Change Order Request

PFAS Well 15

Field Order 11- Curb at Generator Area

CIVIL SITE PLAN

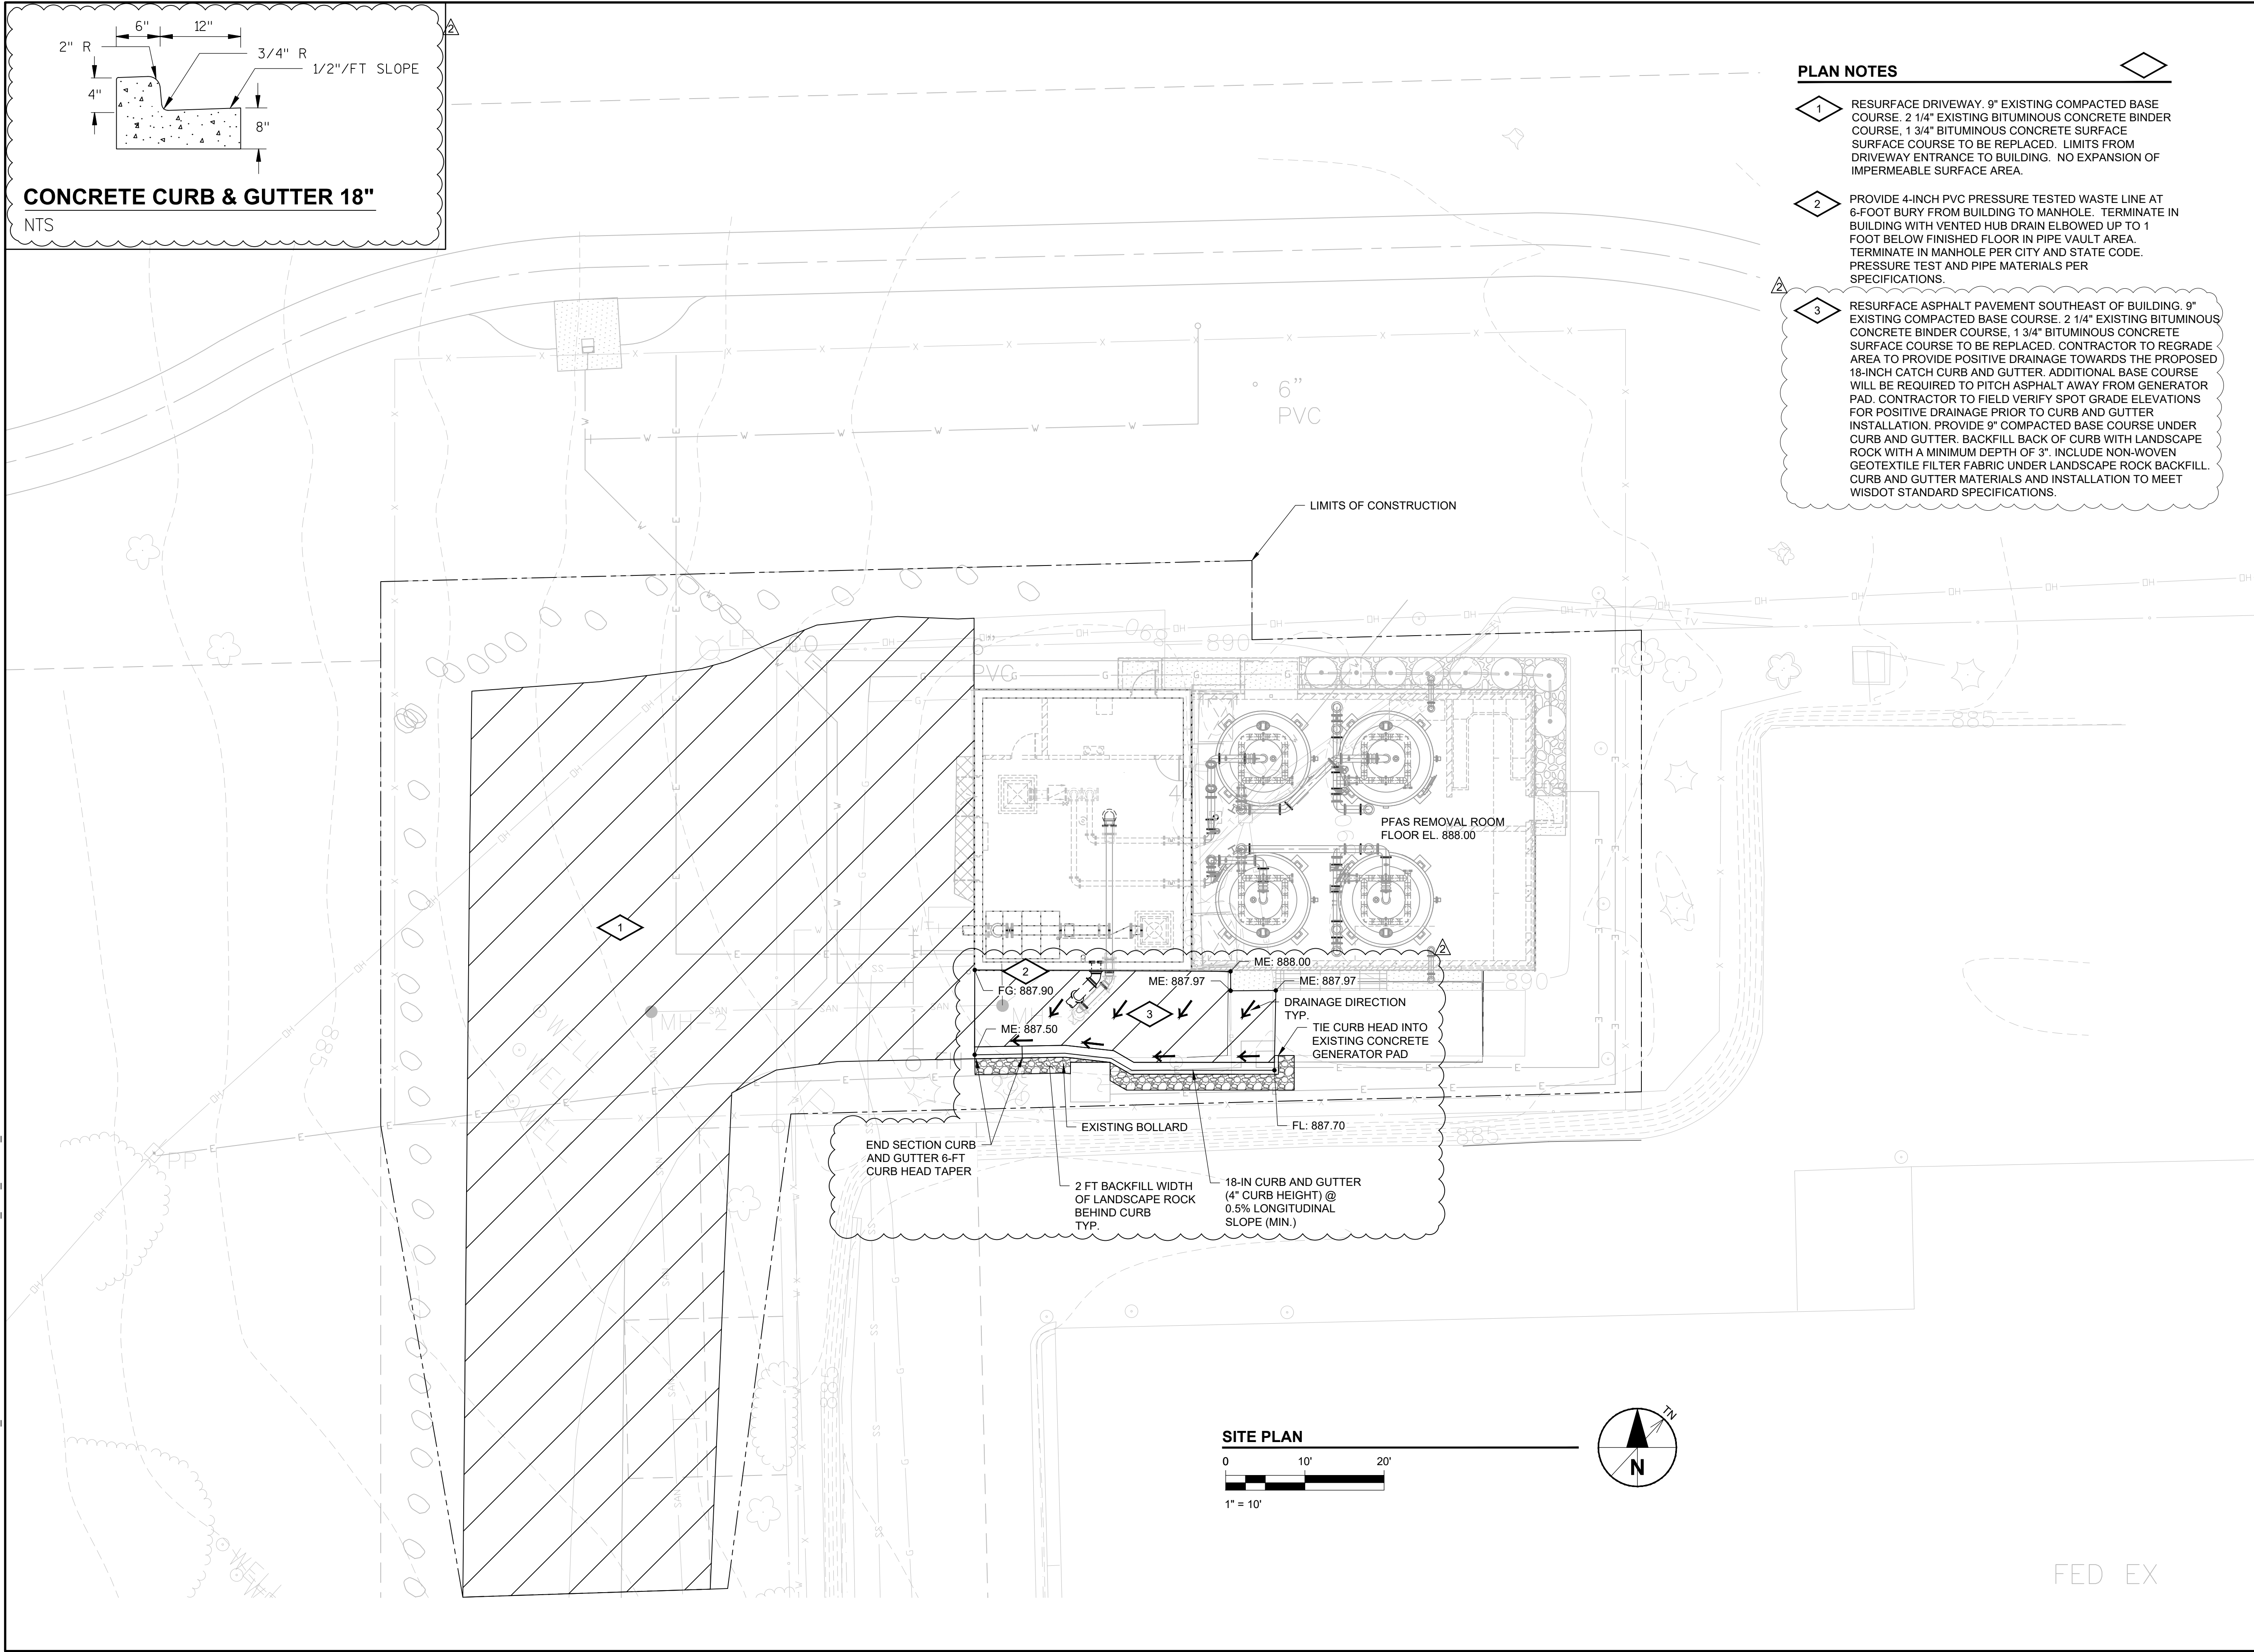
Curb added and additional grading required to slope drainage away from building, generator, and retaining wall.

Drainage from grade and also roof downspout were washing out retaining wall on adjacent property

Install curb, regrade, pave so drainage flows away from generator area

RESURFACE ASPHALT PAVEMENT SOUTHEAST OF BUILDING. 9" EXISTING COMPACTED BASE COURSE, 2 1/4" EXISTING BITUMINOUS CONCRETE BINDER COURSE, 1 3/4" BITUMINOUS CONCRETE SURFACE COURSE TO BE REPLACED. CONTRACTOR TO REGRADE AREA TO PROVIDE POSITIVE DRAINAGE TOWARDS THE PROPOSED 18-INCH CATCH CURB AND GUTTER. ADDITIONAL BASE COURSE WILL BE REQUIRED TO PITCH ASPHALT AWAY FROM GENERATOR PAD. CONTRACTOR TO FIELD VERIFY SPOT GRADE ELEVATIONS FOR POSITIVE DRAINAGE PRIOR TO CURB AND GUTTER INSTALLATION. PROVIDE 9" COMPACTED BASE COURSE UNDER CURB AND GUTTER. BACKFILL BACK OF CURB WITH LANDSCAPE ROCK WITH A MINIMUM DEPTH OF 3". INCLUDE NON-WOVEN GEOTEXTILE FILTER FABRIC UNDER LANDSCAPE ROCK BACKFILL. CURB AND GUTTER MATERIALS AND INSTALLATION TO MEET WISDOT STANDARD SPECIFICATIONS.

FOUNDATION PLAN

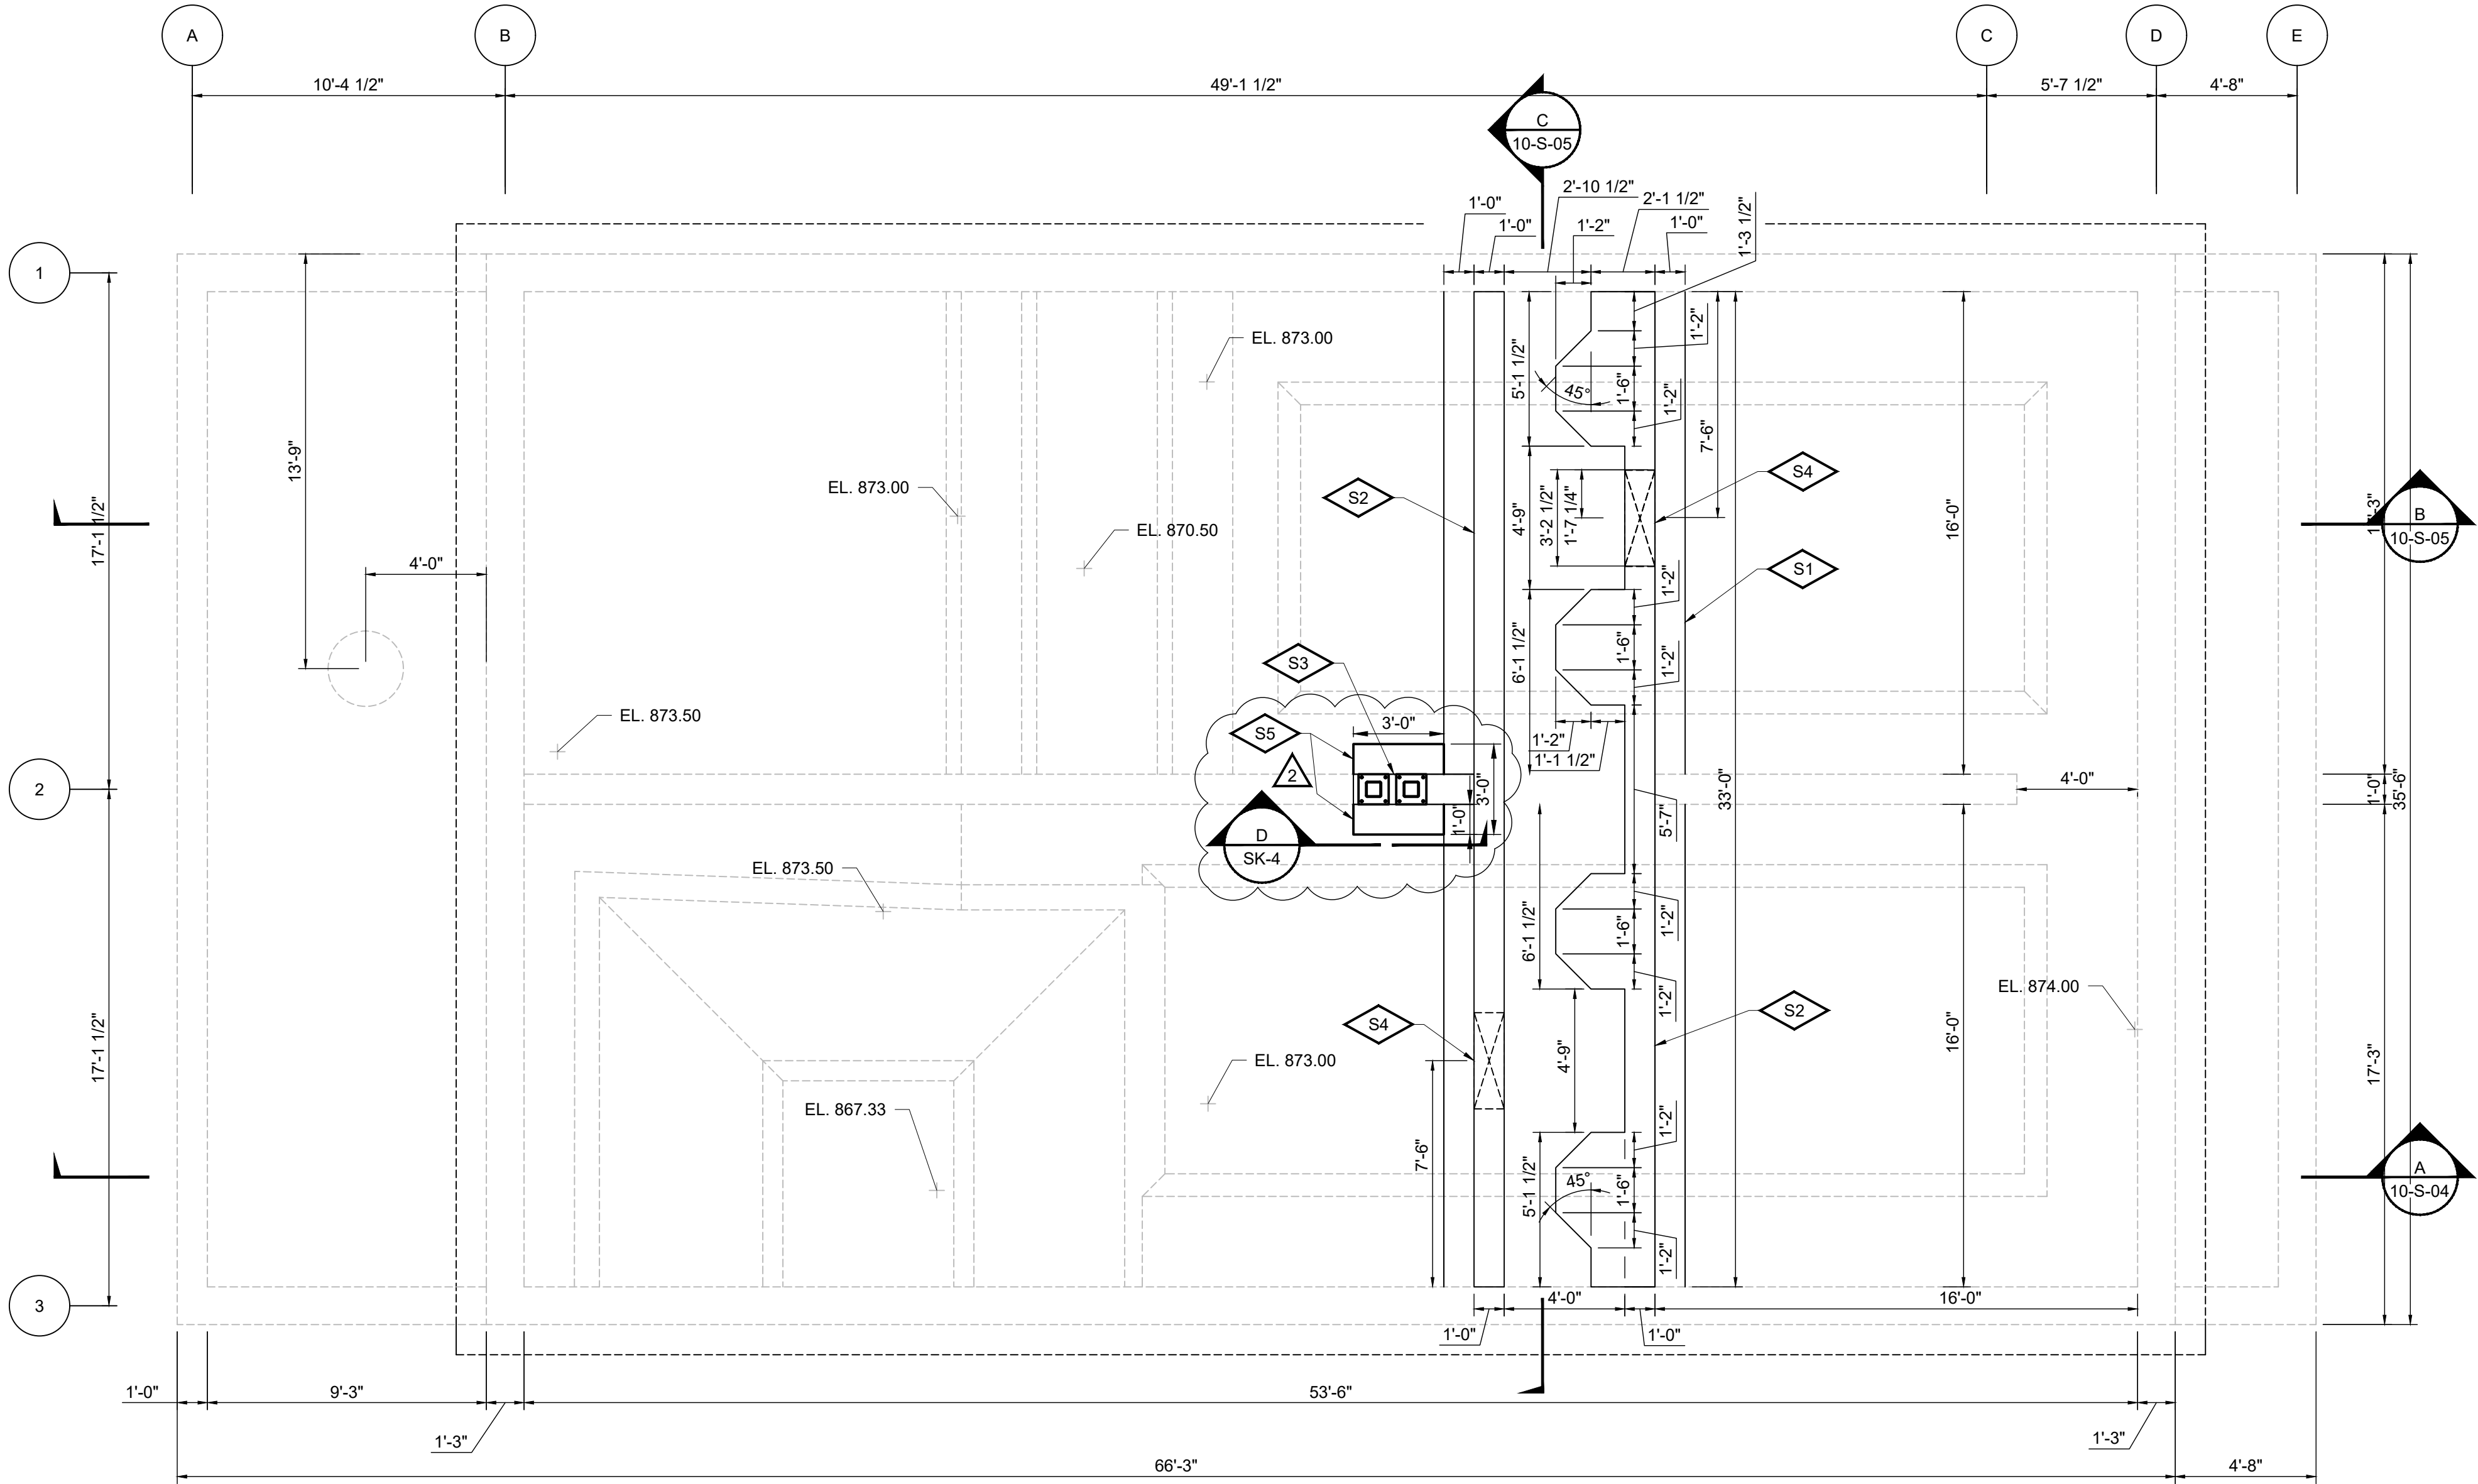
Response to Item 2 – Overcuts in existing floor slab:

1. The existing 5 to 6-inch deep sawcuts at the two locations are to be cleaned out and filled with epoxy by gravity feed with resin method in accordance with the manufacturer's recommended installation procedures.
 - a. Reference: American Concrete Institute's' ACI RAP Bulletin 2 – Field Guide to Concrete Repair Application Procedures, Crack Repair by Gravity Feed with Resin.
 - b. Epoxy material shall be Sikadur-32 Hi-Mod manufactured by Sika Corporation or engineer's approved equivalent.
2. Install steel columns as shown on the attached revised drawing Nos. 10-S-01 and 10-S-08, dated 10/21/24 and Sketch SK-4 dated 10/21/2024 to support existing slab and beam floor system. SK-4 will be incorporated into the As-Built drawings when project is completed.
3. Provide cost and schedule impacts, if any, for this work to AECOM and Owner for review prior to commencement of work.

- S1 CONSTRUCT BASE SLAB TO BE PLACED ON TOP OF EXISTING SLAB
- S2 CONSTRUCT 12-INCH CONCRETE WALL
- S3 NEW OPENING IN WALL TO PROVIDE FLOW BETWEEN TANKS
- S4 ACCESS MANWAY OPENING IN WALL. SEE DETAIL SHEET 10-S-06.
- S5 REFER TO DETAILS ON COLUMN AND FOUNDATION. DWG. SK-4. RESPONSE TO RFI #35.

SK-3 STUB WALL DETAIL

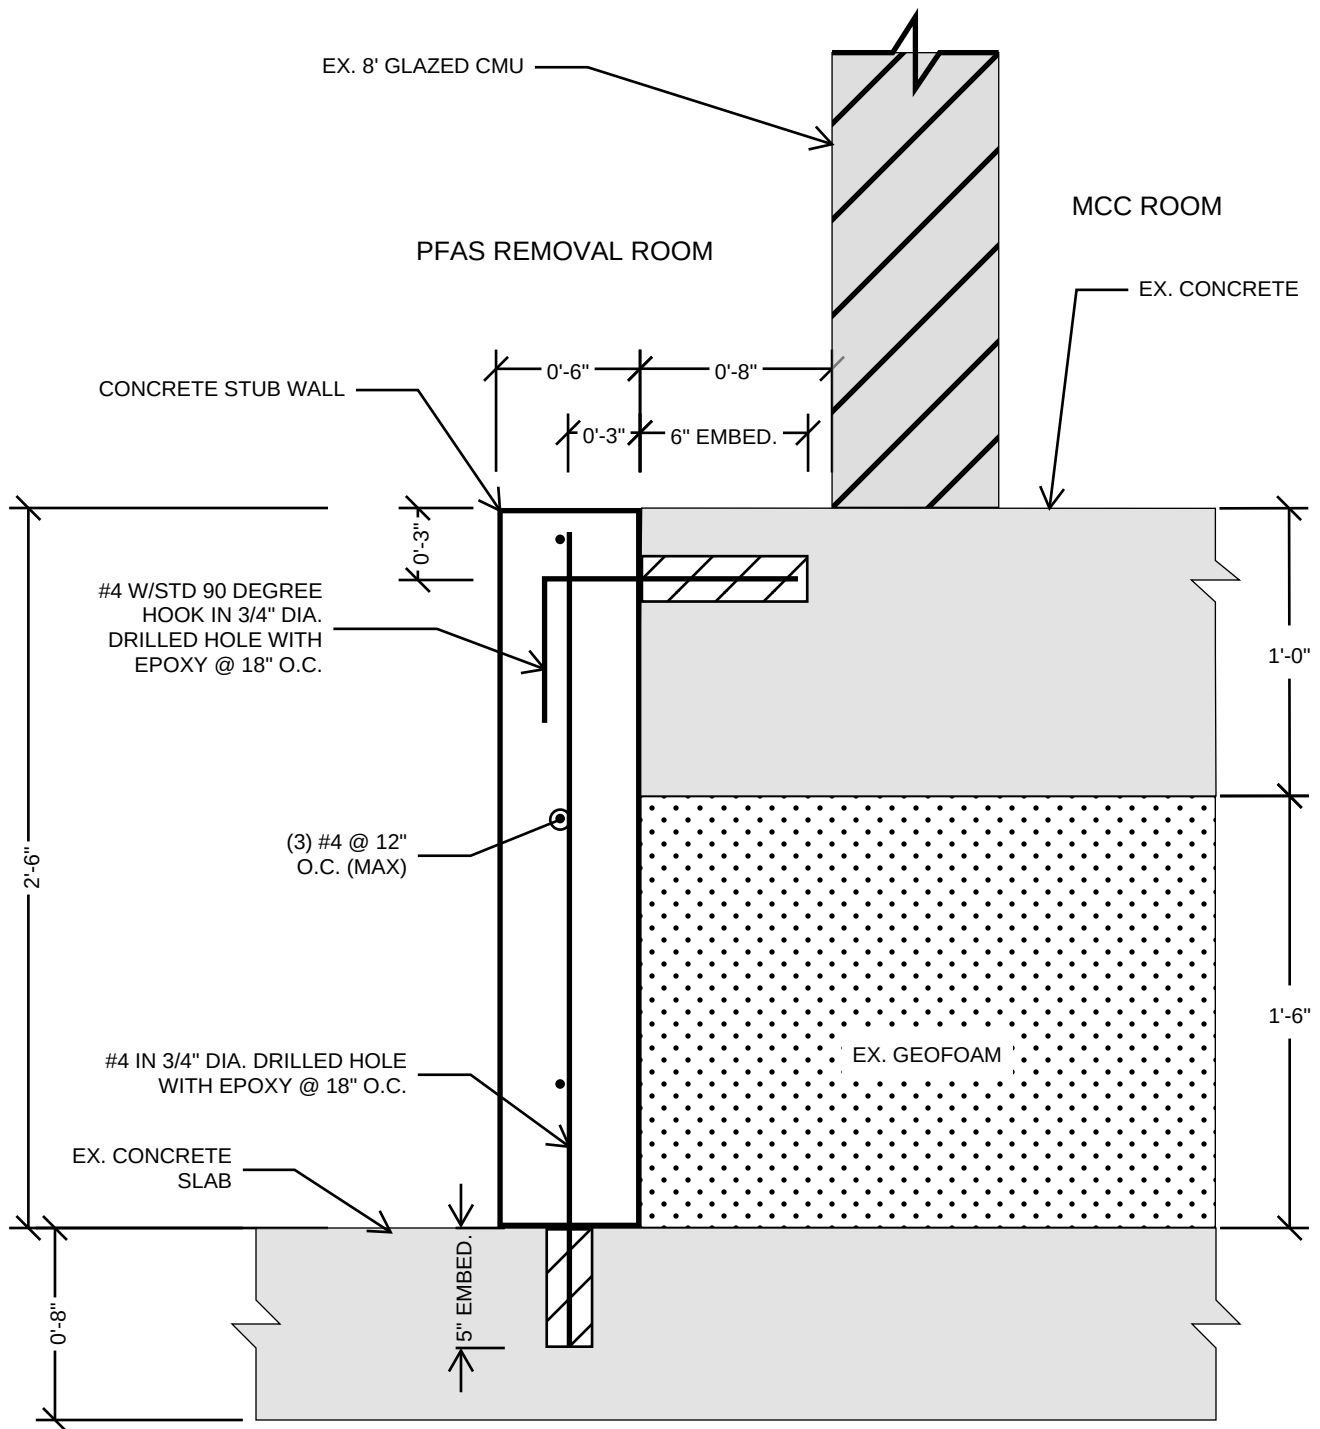
6" wall under east floor at cut, plans show existing to remain. After demo it was discovered there is no existing wall here. We would propose CMU infill under the existing slab as there is not enough room to build a wall out past where the floor is cut without impeding on filter vessel footprint.

1. ADDITIONAL REMOVAL SHOWN ON THIS SHHET IS BASED ON EXISTING CONDITIONS NOTED ON 10/01/2024 DURING SITE VISIT BY AECOM.

2. REFER TO SK-3 FOR 6-INCH STUB WALL TO BE INSTALLED.

1. INFILL VOID BETWEEN EXISTING CONCRETE AND GEOFOAM WITH CONCRETE WHEN PLACING STUB WALL.
2. CONTRACTOR TO FIELD VERIFY ALL DIMENSIONS.
3. COORDINATE WITH OTHER TRADES FOR PENETRATIONS THROUGH STUB WALL PRIOR TO PLACEMENT OF CONCRETE.
